**FINAL MITIGATION PLAN**  
**MIDDENDORF SPRINGS MITIGATION SITE**  
**ANSON COUNTY, NORTH CAROLINA**

DMS Project No.100151  
DWR Project No. 2020-0775v1  
NCDEQ Contract No. 8012-01  
USACE Action ID No. SAW-2021-01973

Re: NCIRT Review and USACE Approval of the NCDMS Middendorf Springs Mitigation Site /  
Anson County

Re: DMS Project ID # 100151 / Middendorf Springs Stream and Wetland Mitigation Site Mitigation Plan  
IRT Comments

CONSTRUCTED RIFFLE  
SCALE: NTS

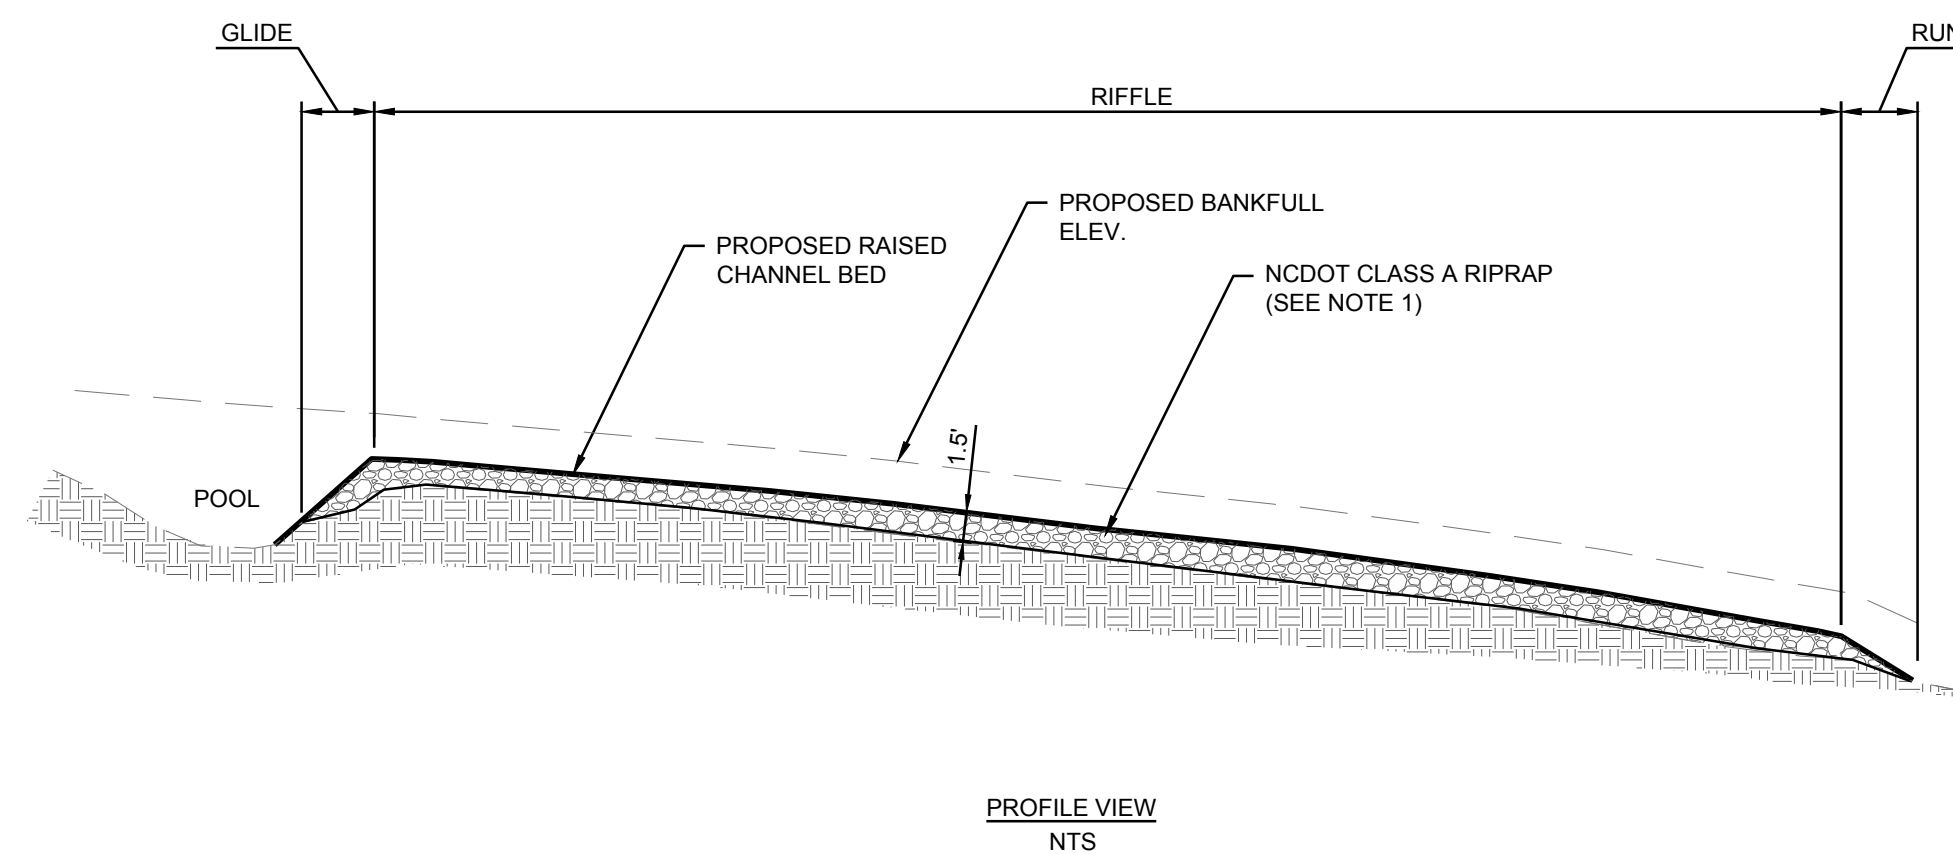
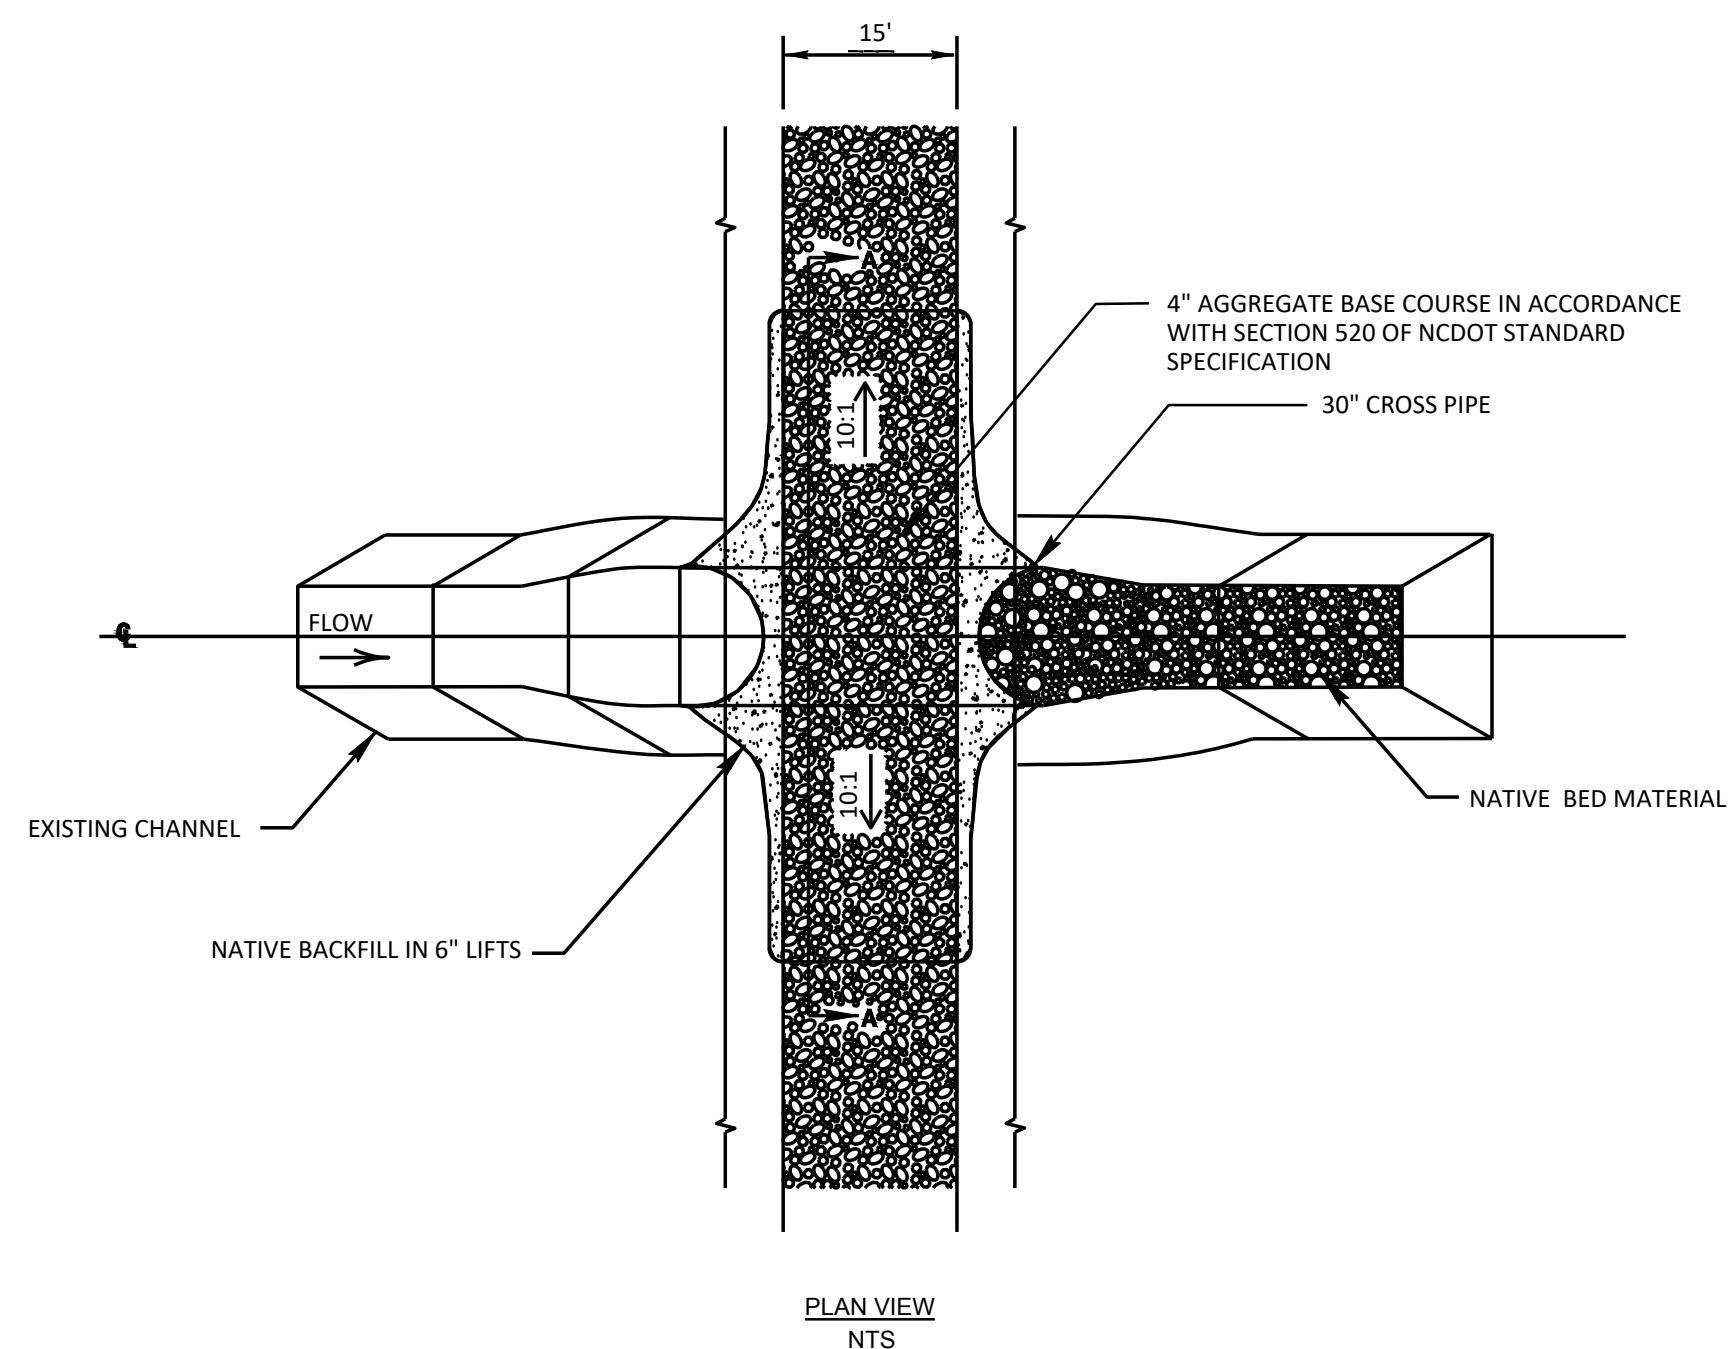
17. **Design sheet DT4- DWR requests the designer look for rock on site which will be more suitable for the stream rather than using NCDOT Class A rip rap.**

See response to DWR Comment #6.
